## Annex 14

# Less densely populated areas – site counts

- A14.1 This annex presents an update on the work carried out by Ofcom to estimate the total number of base stations needed to deploy a basic 3G service in less densely populated areas using 900MHz, 1800MHz and 2100MHz spectrum.

**Figure 2: Analysis of the population density for the area around Horsham**

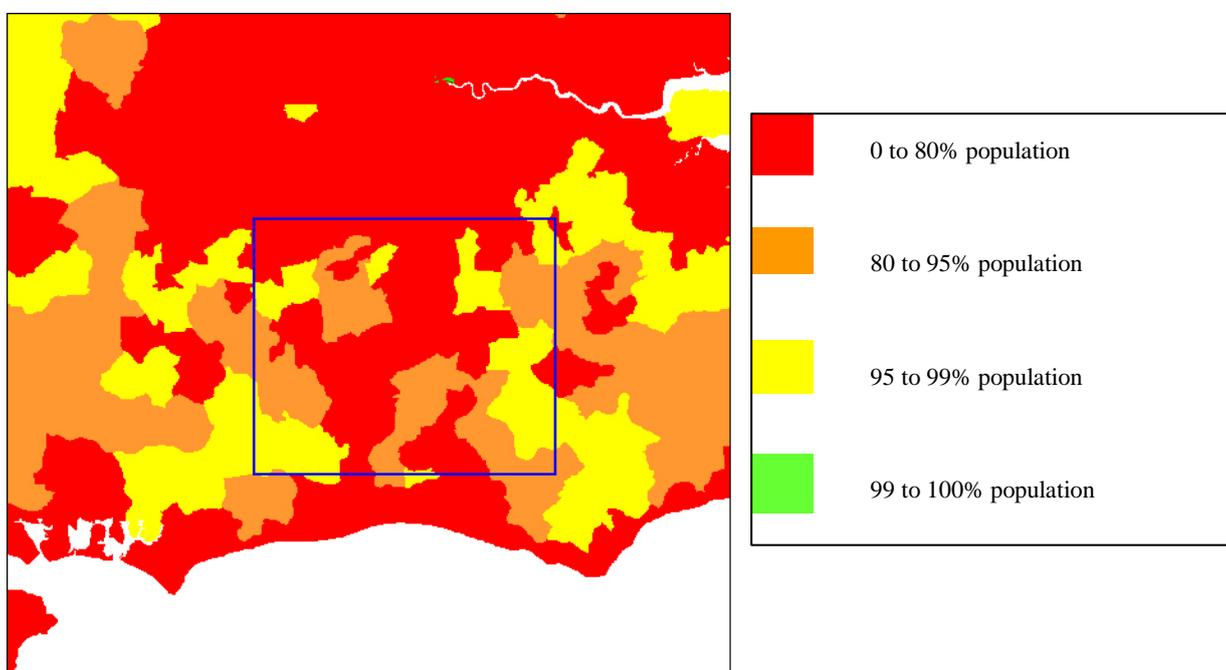
- **Response:** It is inappropriate to seek to draw conclusions on rural base station densities from the West Sussex drive tests. There are a number of specific constraints and local population density issues in this area which differ from the rest of the UK.

**Ofcom comment:** The area around Horsham was cell planned using 900MHz, 1800MHz and 2100MHz spectrum. The sites classified in the less densely populated areas were used to obtain an estimate of respective site densities for different frequency networks.

A14.34 Figure 2 shows that the planned area has a range of population densities.

A14.35 We consider that it is appropriate to consider the cell planning of rural areas around Horsham as an indicative measure of potential advantages of the availability of 900MHz spectrum over other access to 1800MHz or 2100MHz to understand the potential scale of the cost differences.
